## APPENDIX B

The following modifications to the Specific Plan have been proposed since its release in November 1997. These modifications are a result of corrections to the Specific Plan, urban design changes to better reflect a New Urbanist design concepts, and changes recommended to be incorporated due to the staff recommended Alternative.

Alternative 6  
 (Hybrid)

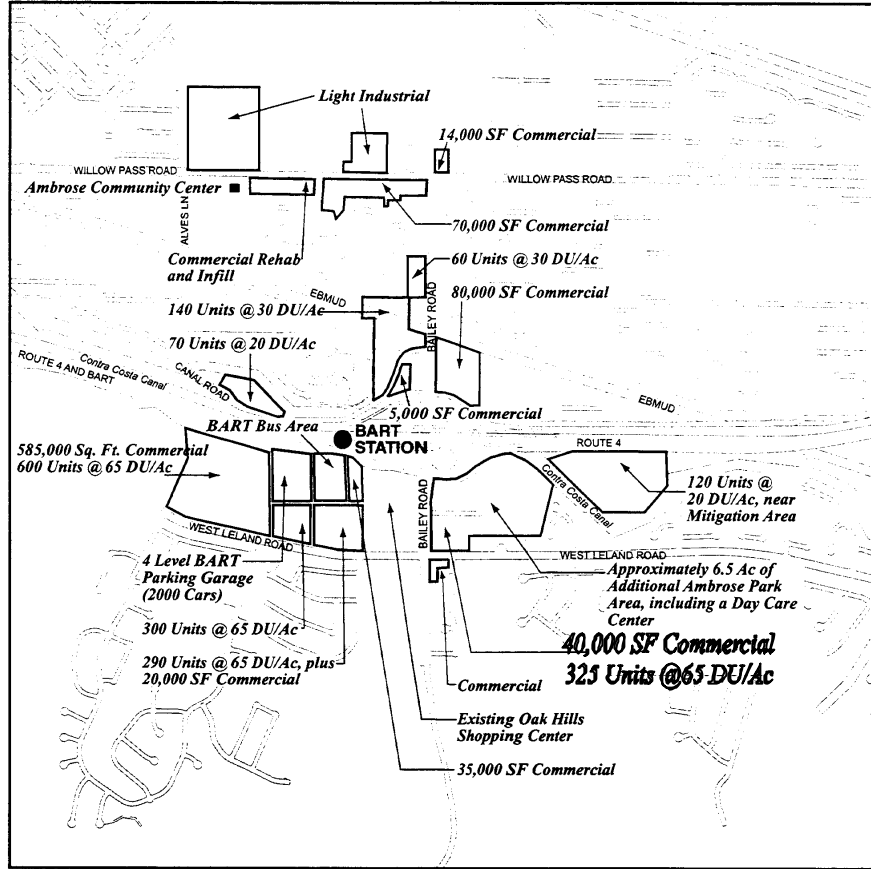
Delete "Alves Lane Road Extension over Highway 4 to West Leland". Replace existing Figure 9 with Figure on following page to reflect staff recommended alternative:

Staff Recommended Alternative (Alternative 6)  
Land Use Designations

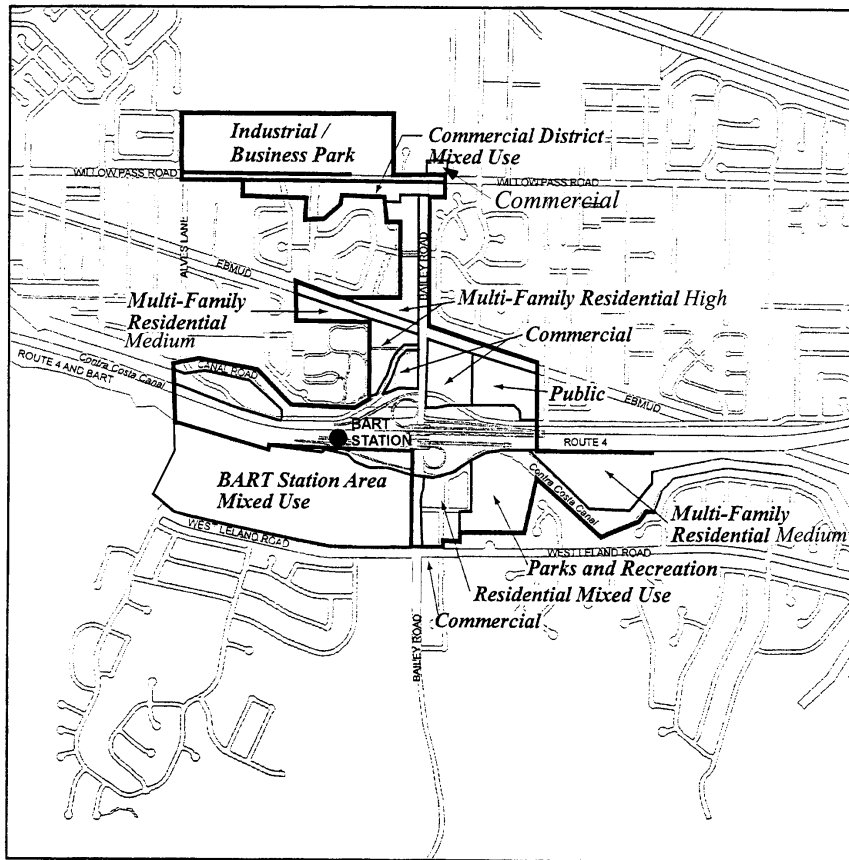
2.12 Figure 10 Replace the existing Figure 10 - Land Use Designation with the following figure to reflect the staff recommended alternative:
